FINDING OF NO SIGNIFICANT IMPACT

National Mall Turf and Soil Reconstruction

National Mall and Memorial Parks

NATIONAL MALL TURF AND SOIL RECONSTRUCTION NATIONAL MALL AND MEMORIAL PARKS ENVIRONMENTAL ASSESSMENT – ERRATA

Figure 2.4 – Option B1 Soil Fracturing

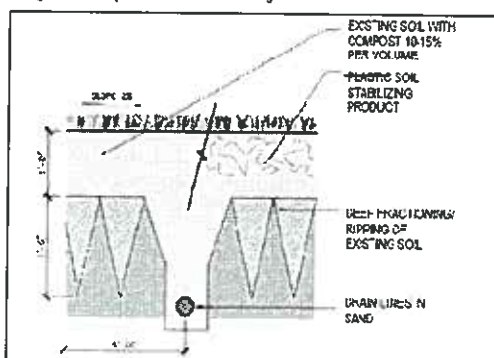
All three figures in this section are revised to eliminate the plastic soil stabilizing product, consistent with the text. This product, which was considered then dismissed as impractical and environmentally undesirable during internal review, was erroneously included in the figures.
